Inland Transport Committee

World Forum for Harmonization of Vehicle Regulations

Proposal for the 03 series of amendment to UN Regulation No. 127 (Pedestrian safety)

Submitted by the Working Party on Passive Safety *

Figure 5
Example of marking of HIC1000 zone and HIC1700 zone

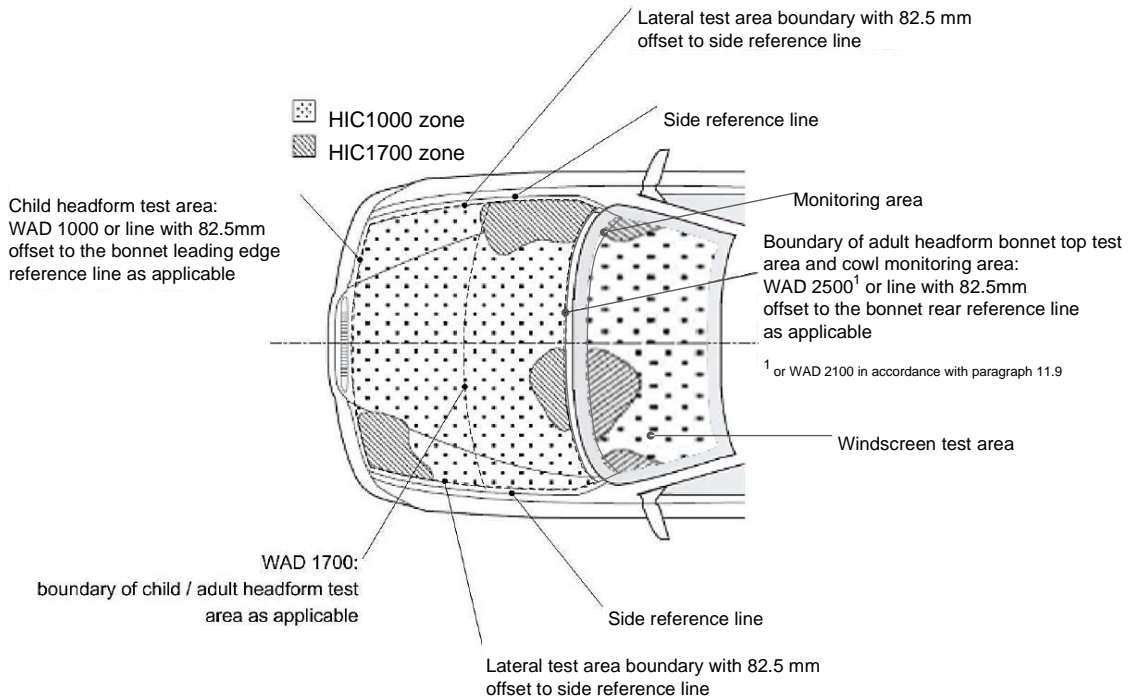
"3.4.1. The manufacturer shall identify the zones of the bonnet top test area and of the windscreen test area where the HIC shall not exceed 1,000 (HIC1000 zone) or 1,700 (HIC1700 zone) (see Figure 5).

3.4.2. Marking of the "bonnet top" test area, marking of the windscreen test area as well as "HIC1000 zone" and "HIC1700 zone" will be based on a drawing supplied by the manufacturer, when viewed from a horizontal plane above the vehicle that is parallel to the vehicle horizontal zero plane. A sufficient number of x and y co-ordinates shall be supplied by the manufacturer to mark up the areas on the actual vehicle while considering the vehicle outer contour in the z direction. The cowl monitoring area is not considered for the marking of the "HIC1000 zone" and "HIC1700 zone".
